**MANASQUAN PLANNING BOARD MEETING AGENDA
CONDUCTED WITH ZOOM
JULY 05, 2022 7:00 PM – TUESDAY**

Re: Boro File No. MSPB-R1480
Variance – Tackett
Block 165, Lot 30
75 Beachfront
R-4 Single-Family Residential Zone
Borough of Manasquan, Monmouth County, NJ

Re: Boro File No. MSPB-R1870
Use Variance/Major Subdivision/Site Plan – Ocean Bay Developers LLC
Block 23, Lots 7.02 & 10
39 South Street
B-1 - Business Zone
Borough of Manasquan, Monmouth County, NJ

PRELIMINARY/FINAL SUBDIVISION & SITE PLAN **Scope Engineering inc.**
 Consulting Engineers
 CERTIFICATE No. 246A28103200
 P.O. BOX 899
 FORKED RIVER, NJ 08731
 PHONE: 609-971-0700
 FAX: 609-971-0772

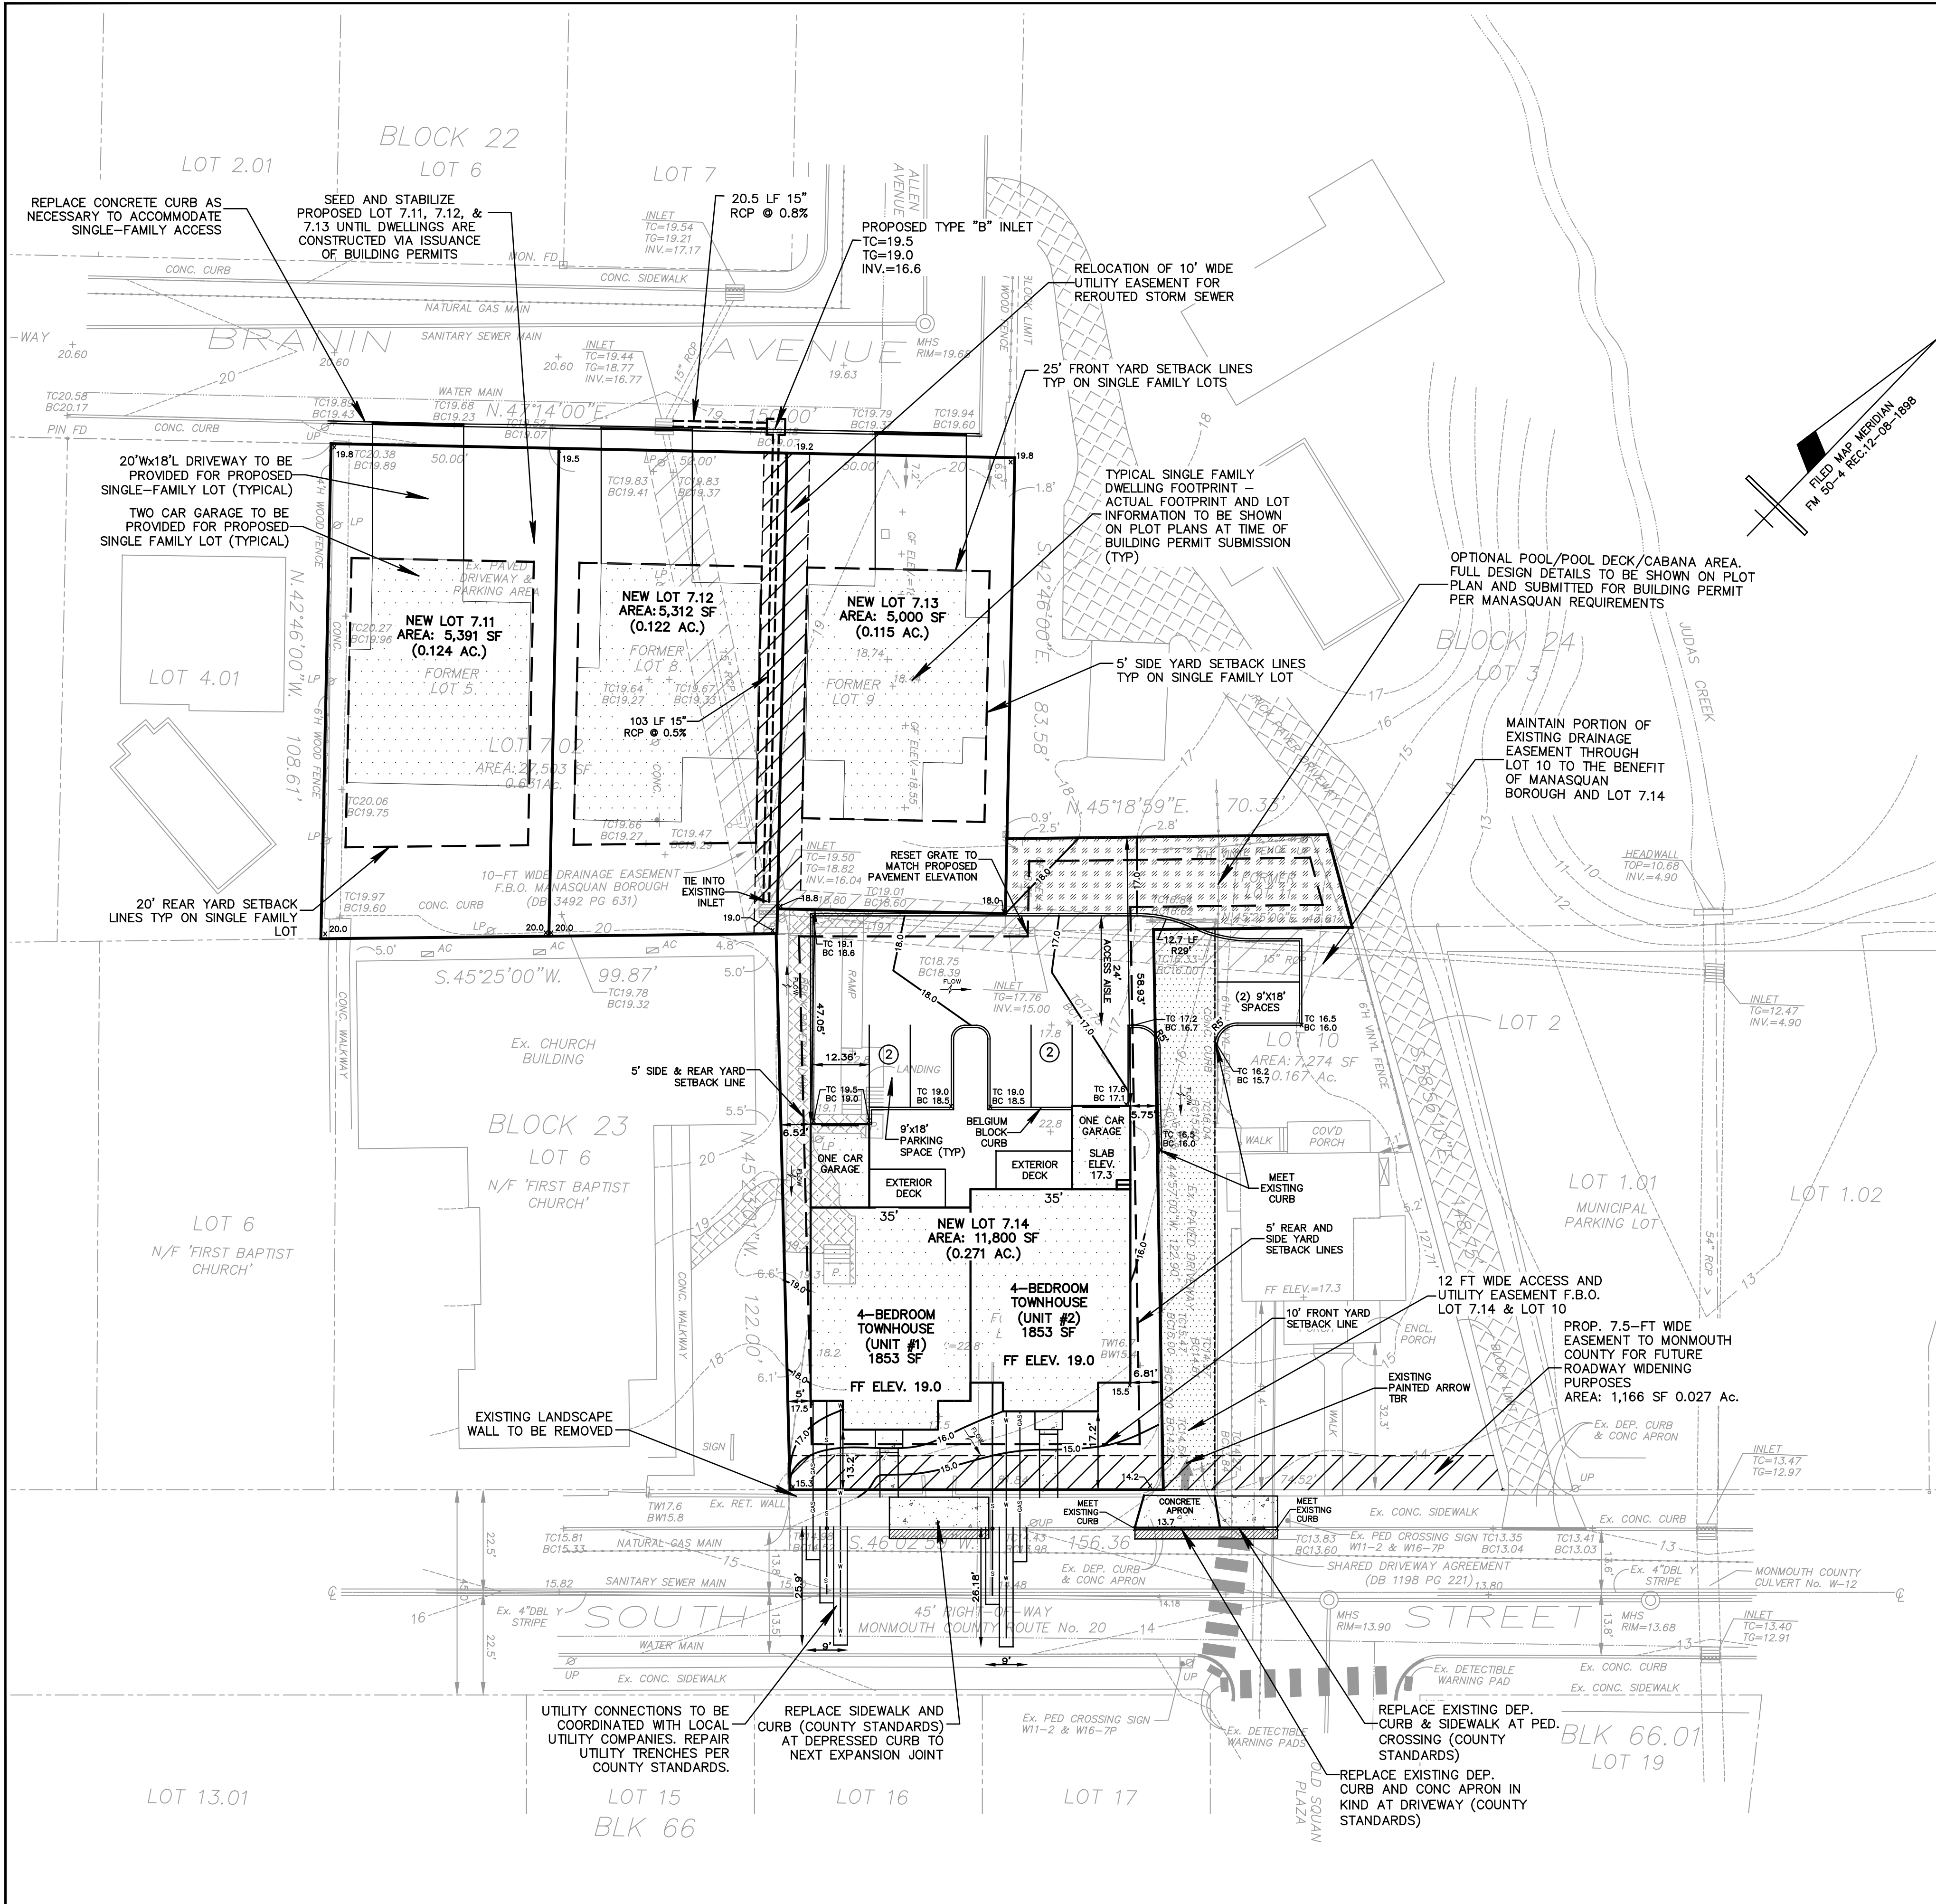
28. Metes and bounds of all proposed easements must be shown on the subdivision plan.
29. All construction details for proposed improvements must be provided, including borough roadway and drainage and all on-site improvements.

SITE PLAN

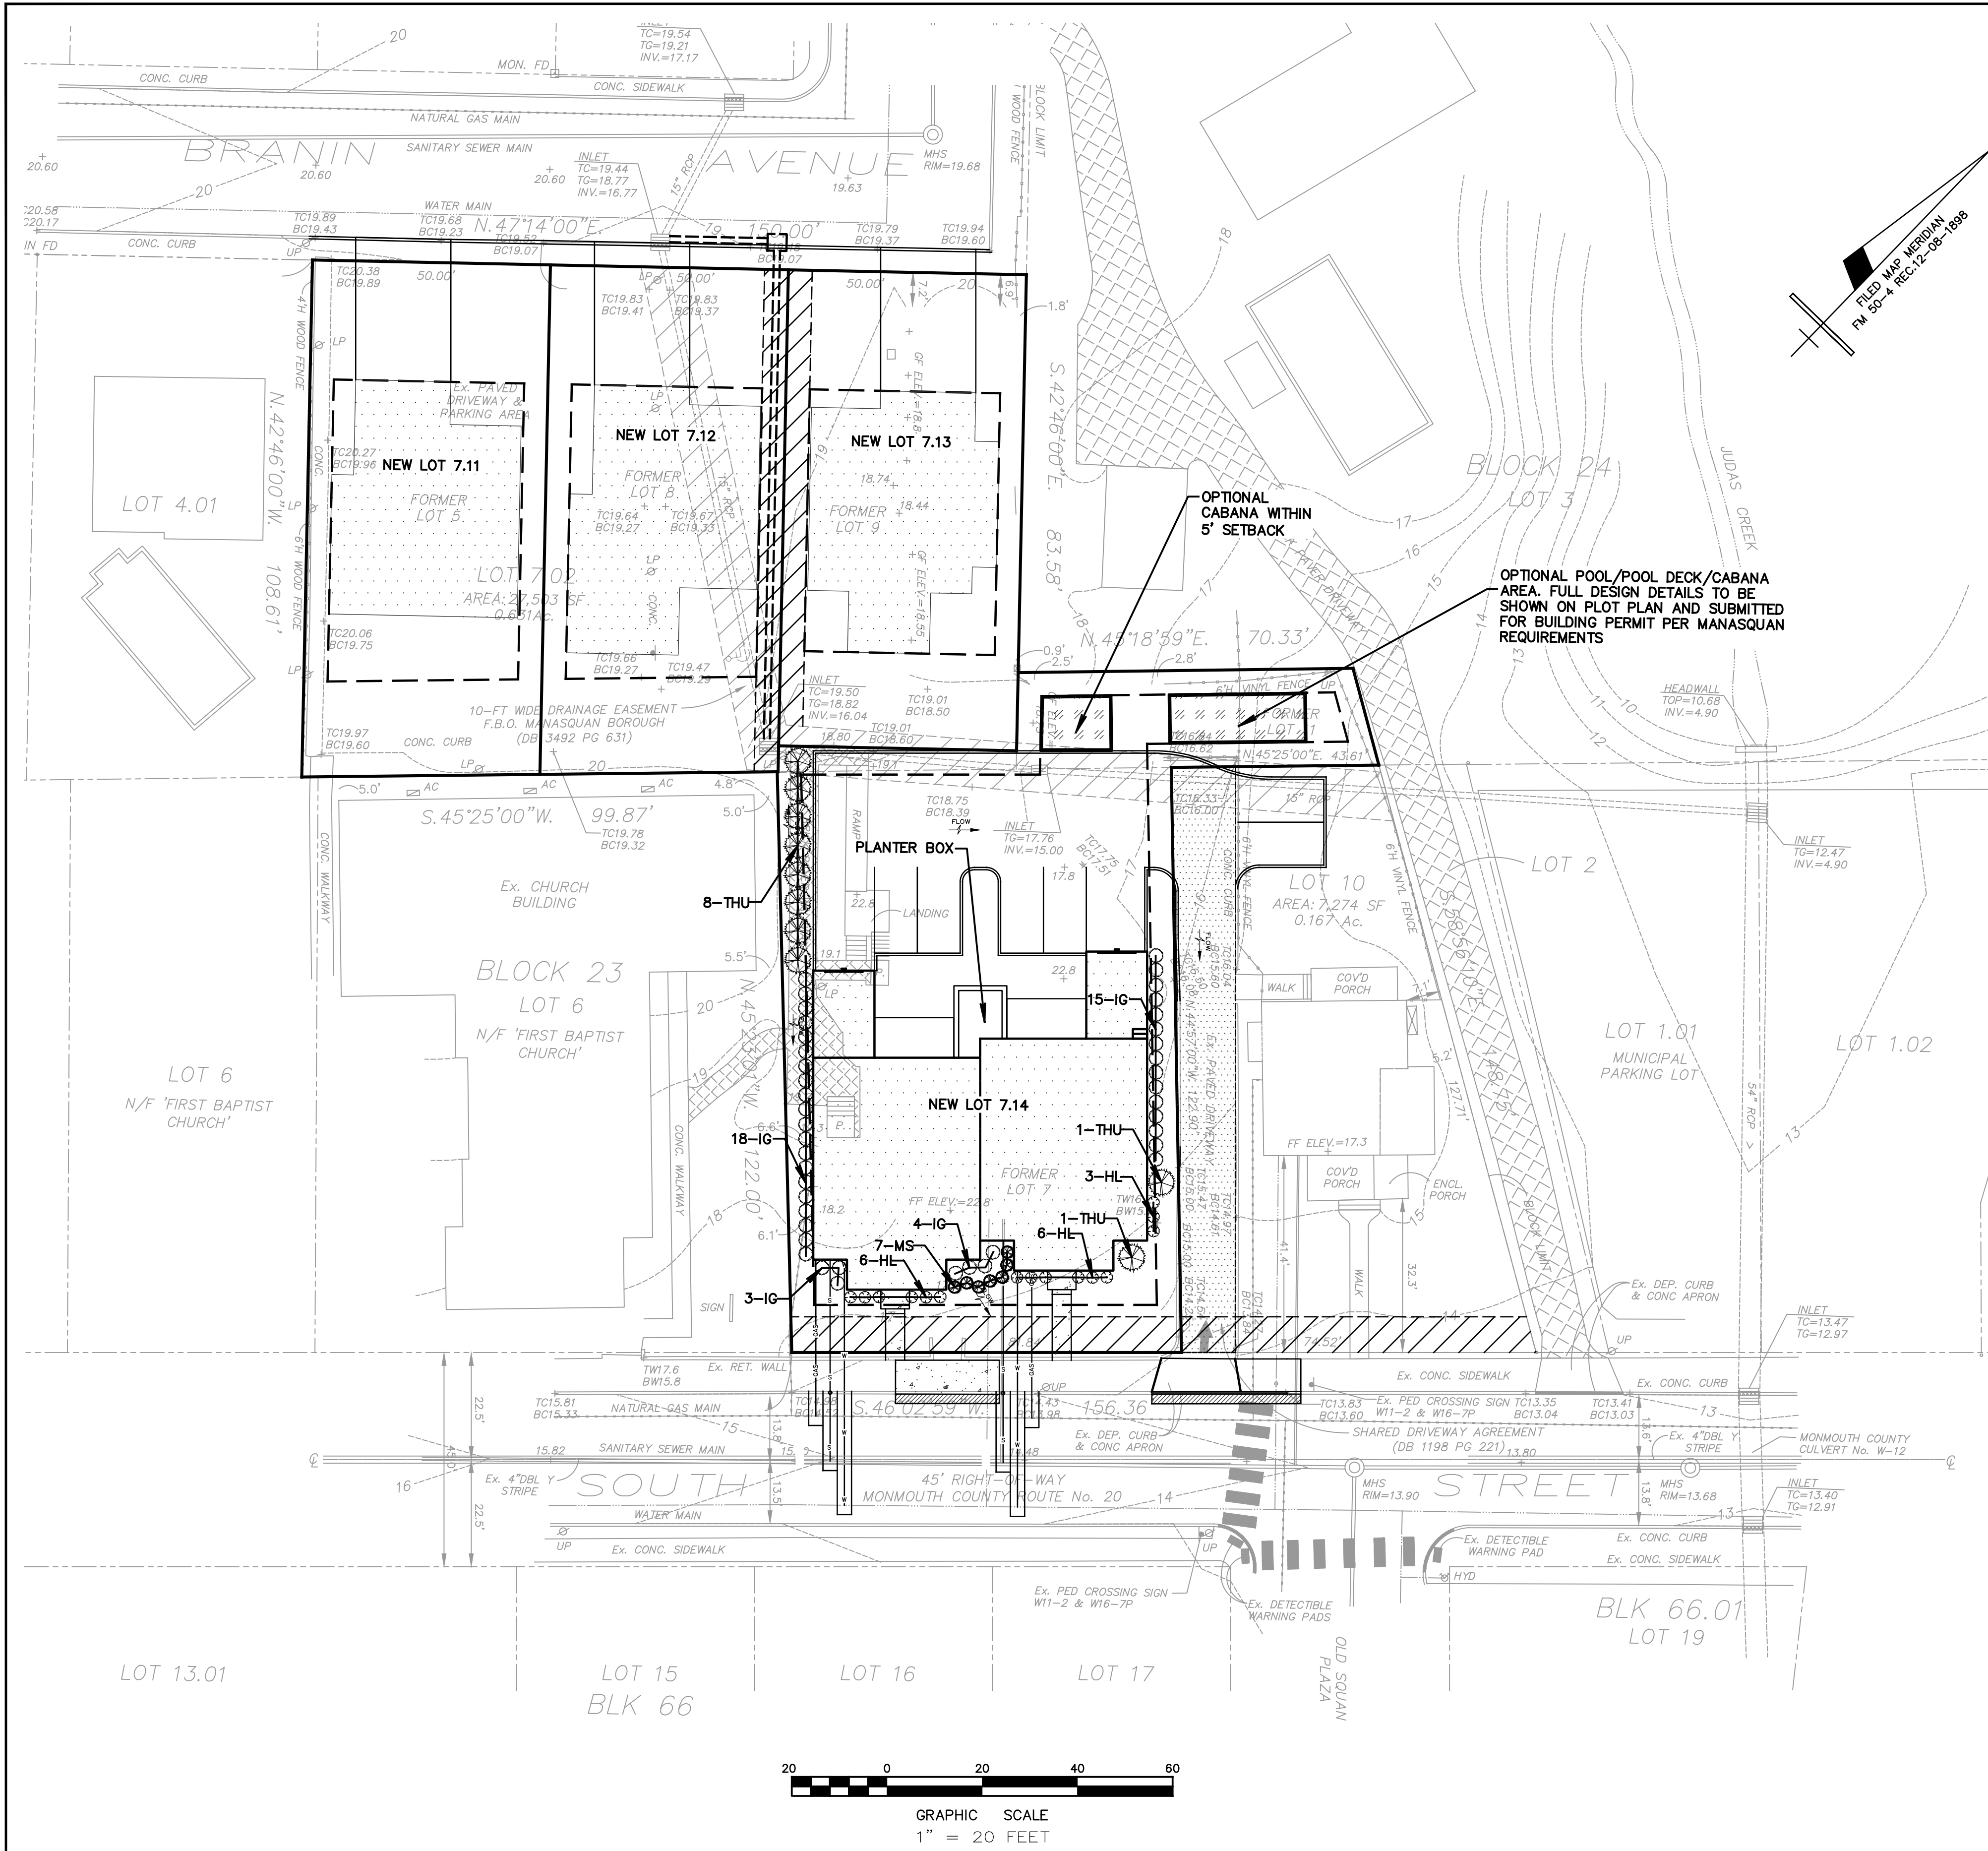
16. The proposed access aisle for the shared driveway for Lots 7.14 and 10 requires a variance for width. The 12 feet wide driveway does not allow for two-way traffic and there does not appear to be an opportunity to widen it or provide a pull off with the current layout. I suggest that at a minimum, signage be provided on the drive aisle indicating that entering traffic has the right-of-way if this is to be considered by the Board.
17. Approval from the County will be required for the future road widening easement versus a full right-of-way dedication.
18. I suggest that the existing driveway be provided with a pavement overlay in conjunction with the new parking area.

19. Any site lighting for the townhomes or parking area, building mounted or freestanding, must be shown on the plans, with lighting levels and details provided.

25. Detectable warning surfaces must be provided for the reconstructed sidewalk at the crosswalk.
26. If housewalk is proposed from the rear parking area to the decks it must be shown on the plan and included in the coverage calculations.
